RFB NO. 313086 - ADDENDUM NO. 6

### ARCTIC ANIMAL EXHIBIT AND CONCESSIONS

This Addendum is issued to modify, explain or clarify the original Request for Bid (RFB) and is hereby made a part of the RFB. Please attach this Addendum to the RFB. **Bidders must acknowledge all Addenda on the Bid Form.**

**SA1.1**

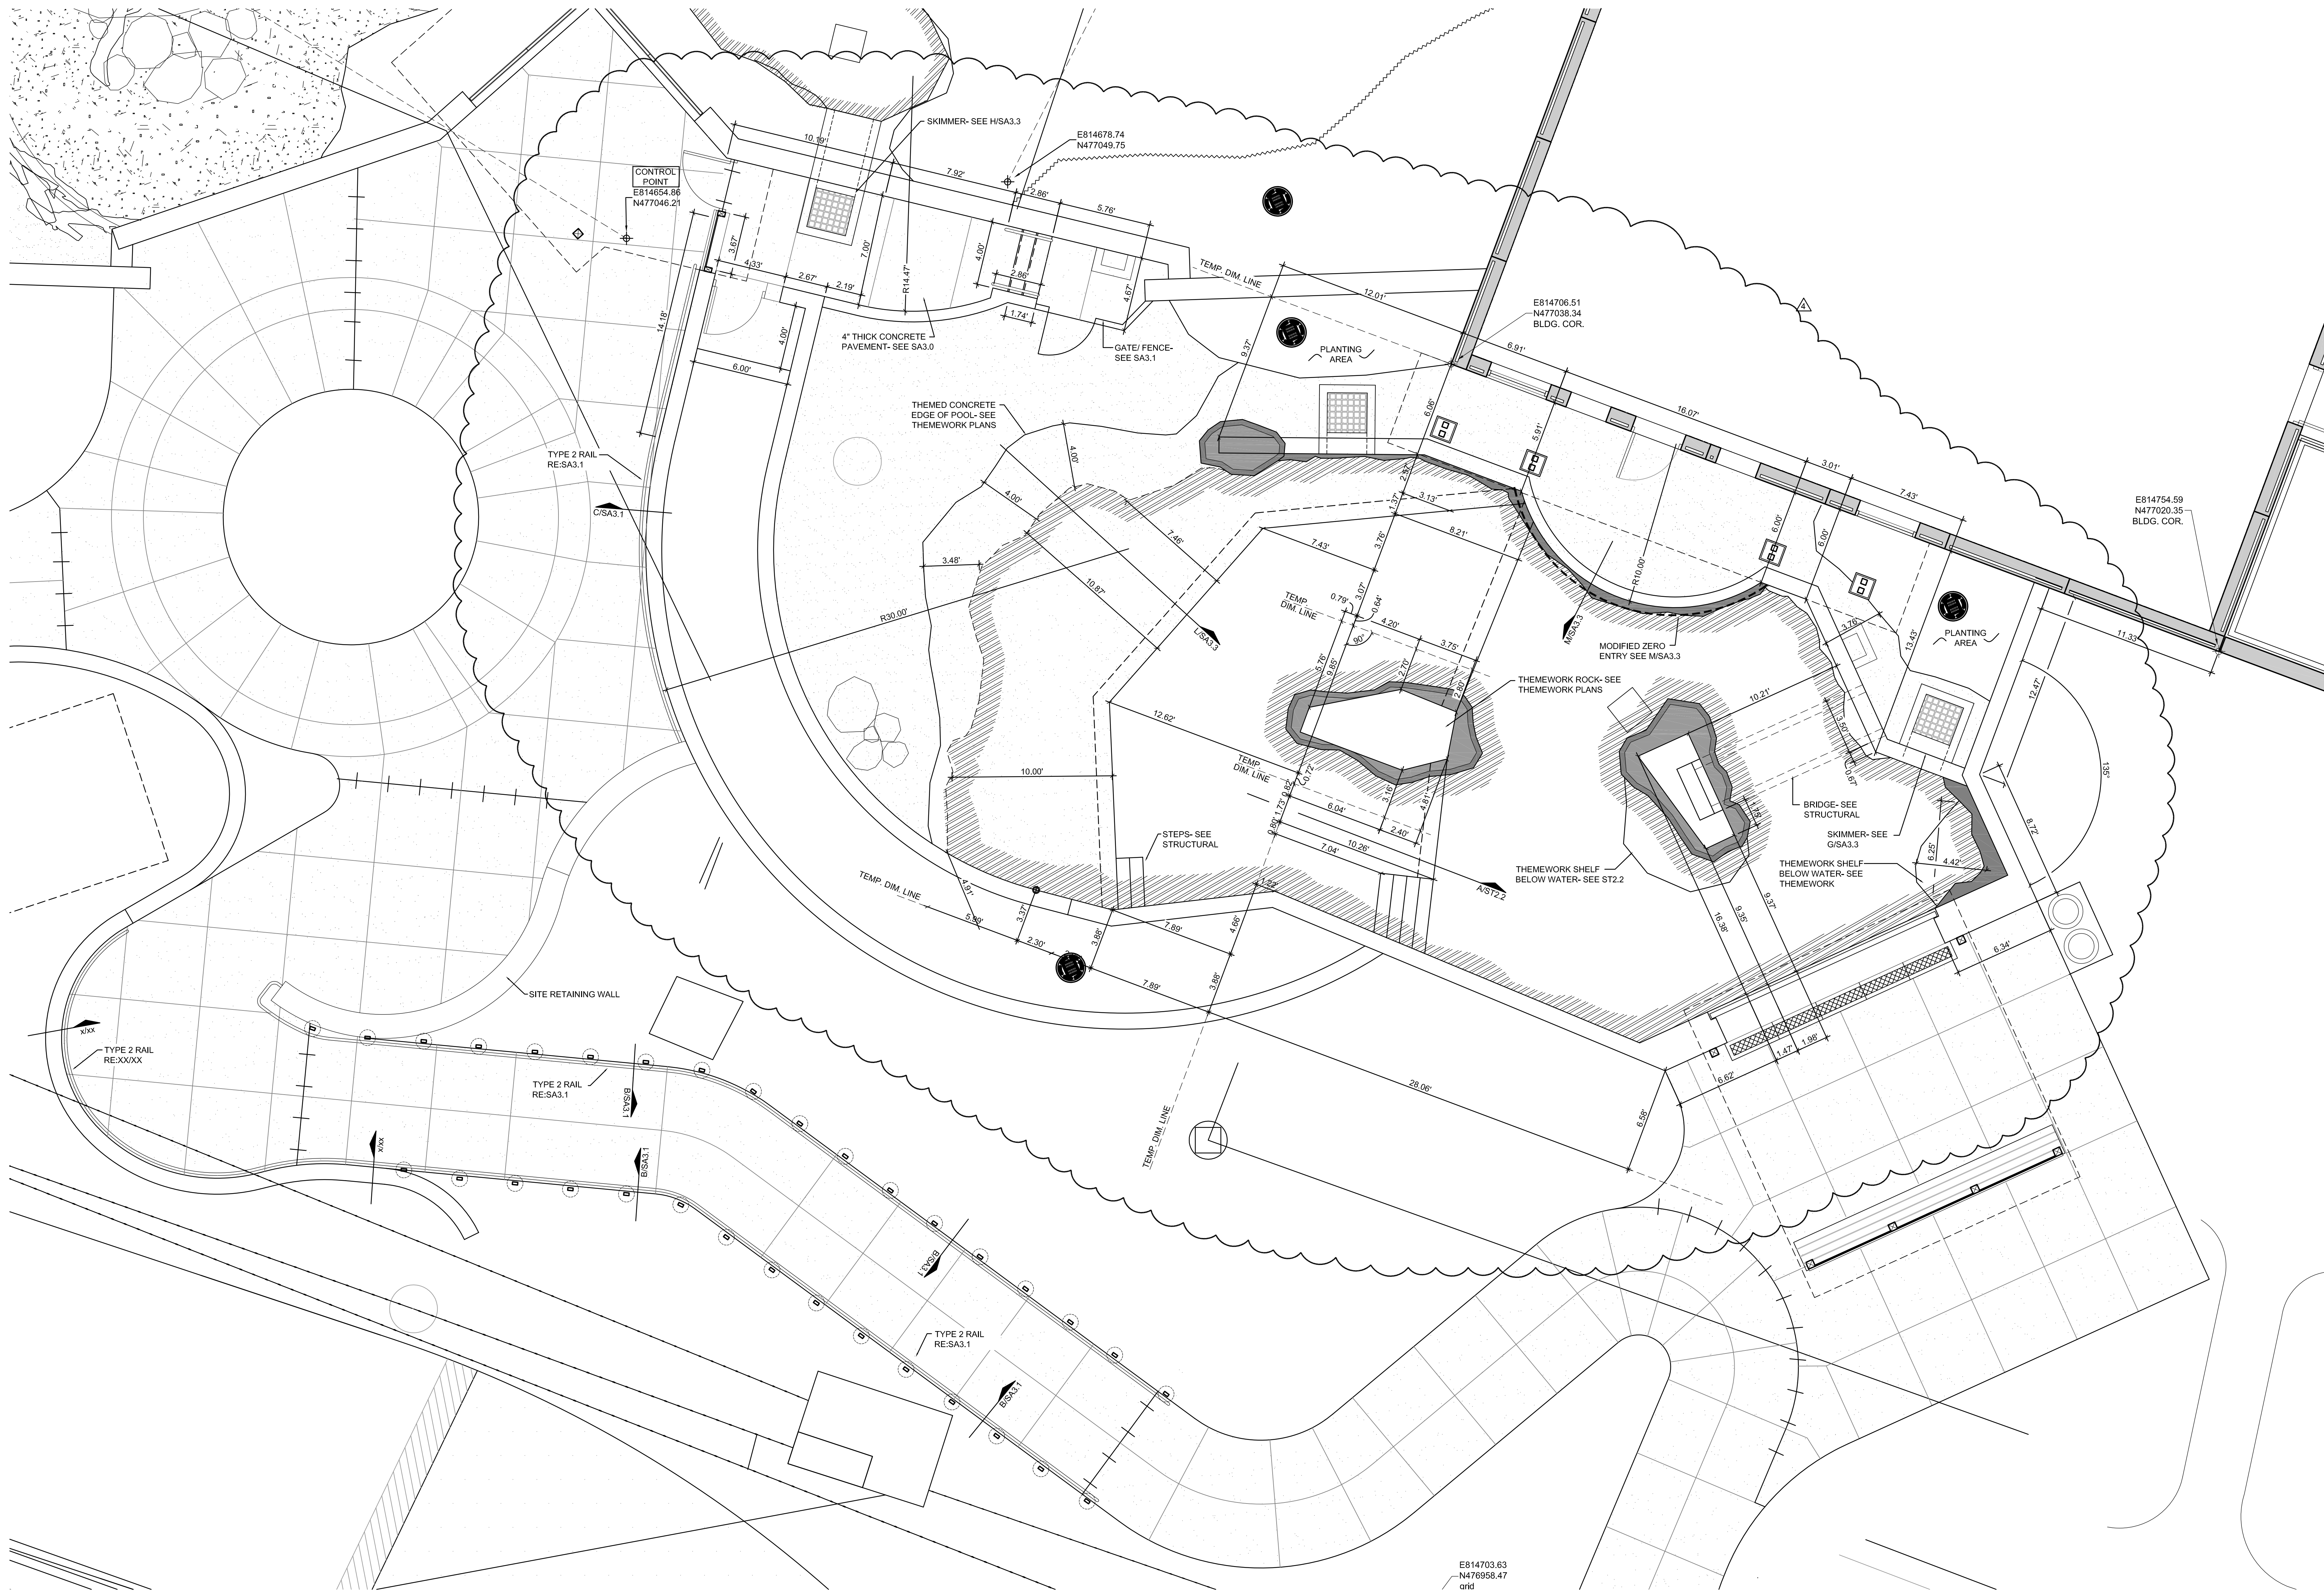
### **9. Sheet SA1.1**

- Added references to pavement thicknesses.

**SA1.8**

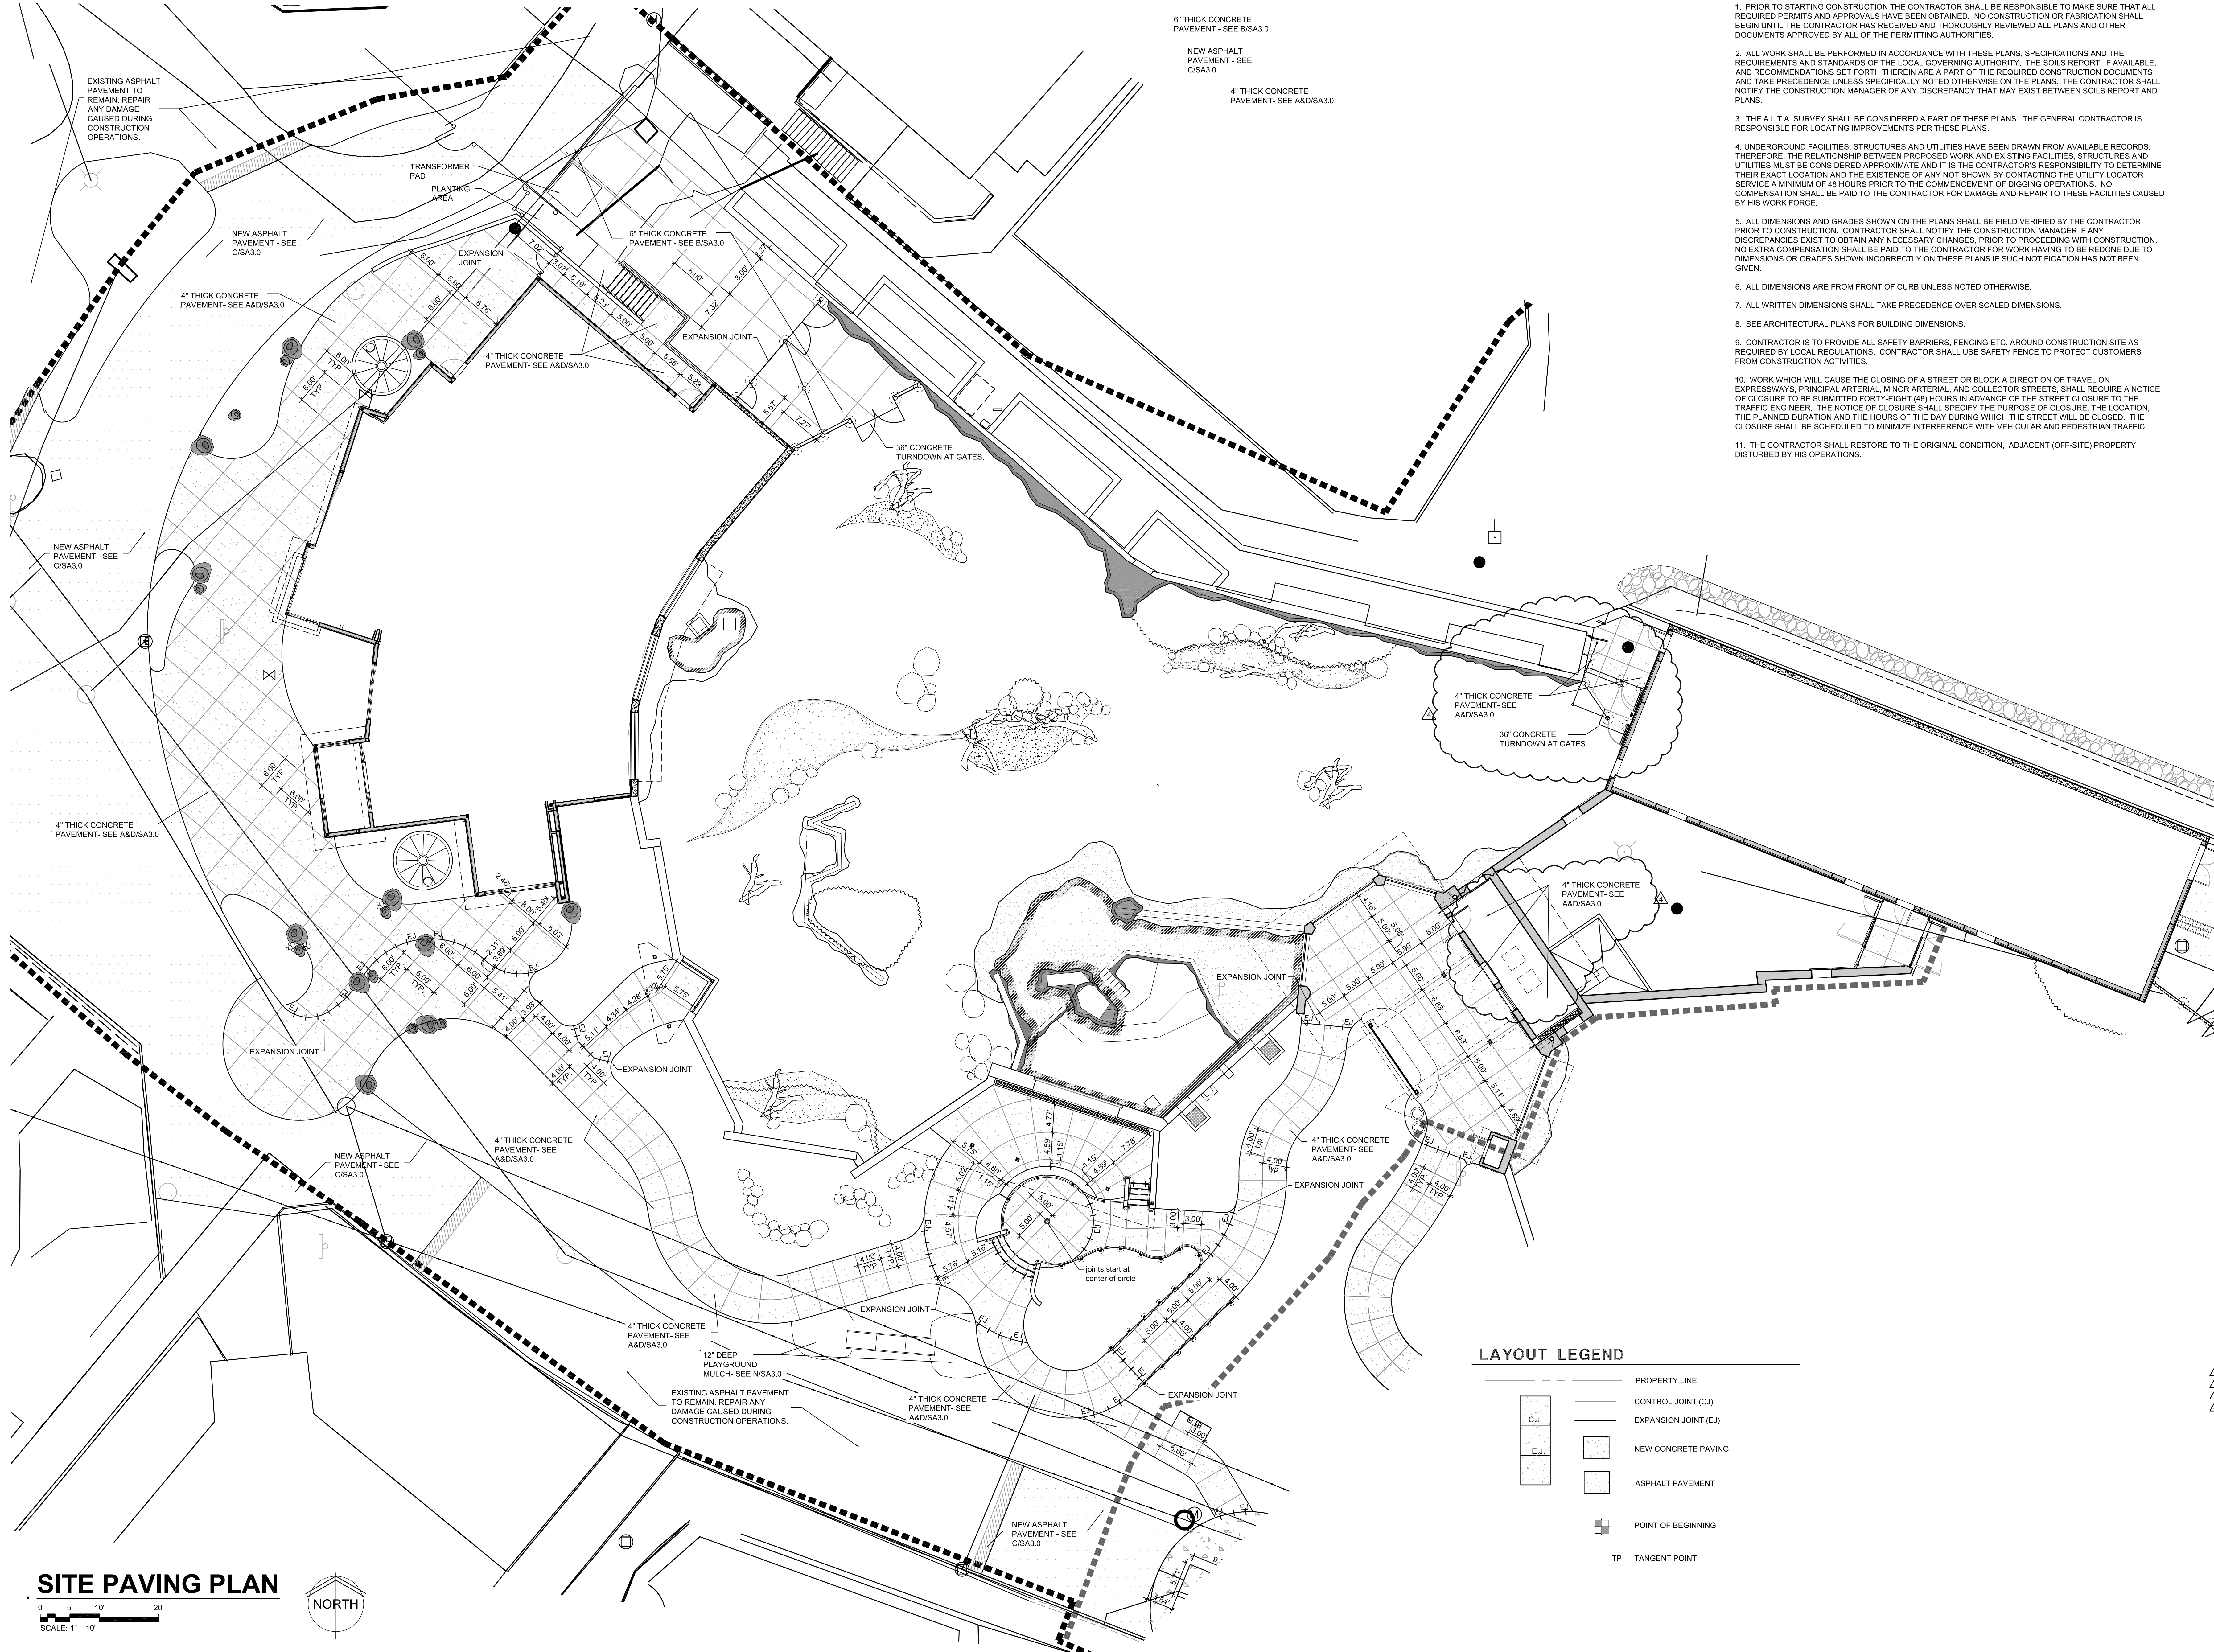
### **10. Sheet SA1.8**

- Modified dimensions at seal pool due to thickened pool walls.
